Technical Service Bulletin

No.LTB00048v5
04 February 2008

Subject/Concern: Creak/Clicking Noise From Rear of the Vehicle

Models:
Freelander 2/LR2 (LF) | | VIN- range: Up to H045063

E97227

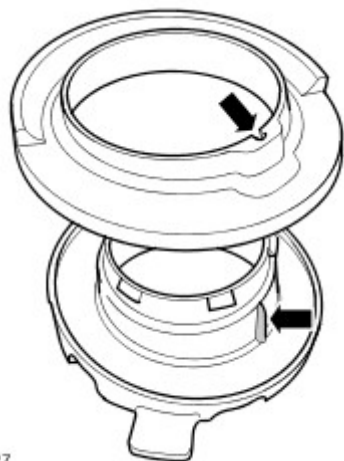
CAUTION: The new isolator and wedge must be oriented correctly with the notch and tang engaged. (see E97227).

Install a new isolator and wedge on the removed spring.
